SUBJECT: CRYSTAL RIVER UNIT 3 - NRC COMMENTS ON THE OFFSITE DOSE  
CALCULATION MANUAL

NRC COMMENTS ON THE PROPOSED CRYSTAL RIVER UNIT 3  
OFFSITE DOSE CALCULATION MANUAL (ODCM)

FIGURE 5.1

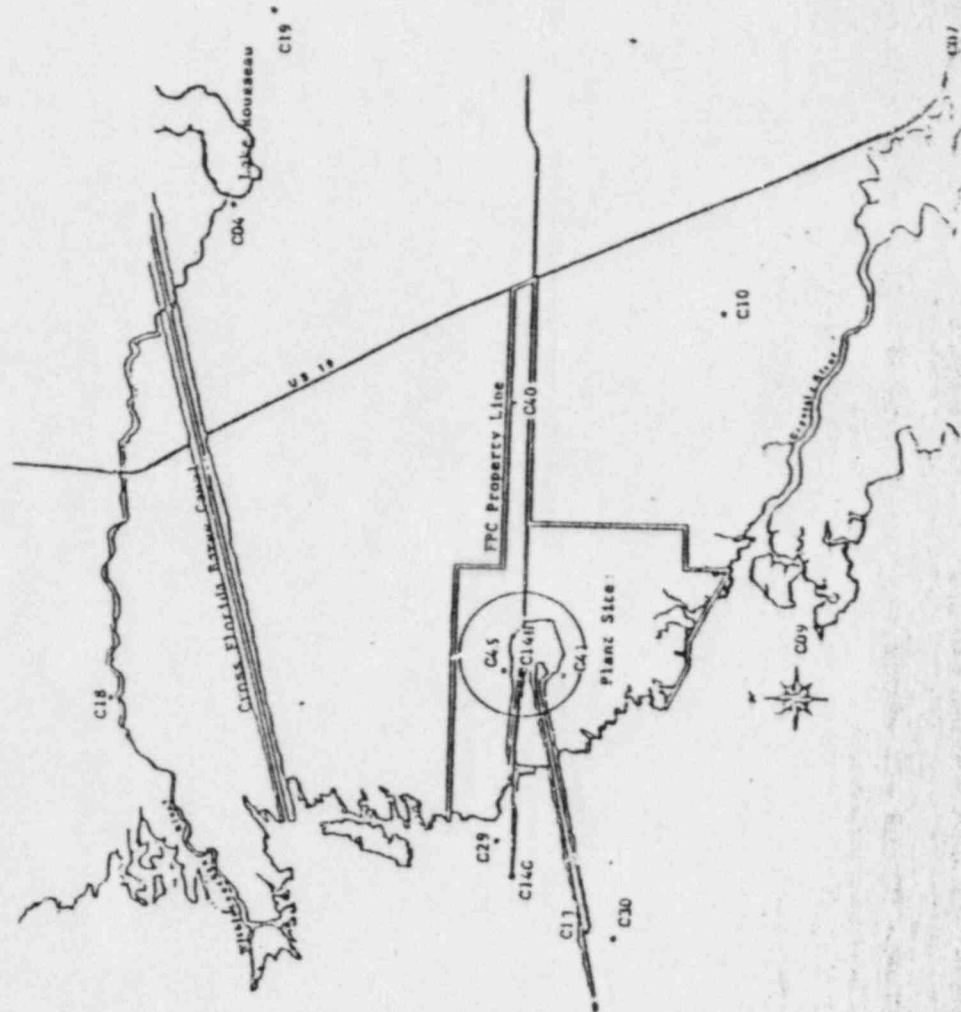
8. The following sample locations were omitted:

Sample Location Omitted

Table 5.1-2	C27
Table 5.1-1	C14M, C09, C48
Figure 5.1	C14M, C48

Note: C09 is identified in Figure 5.1
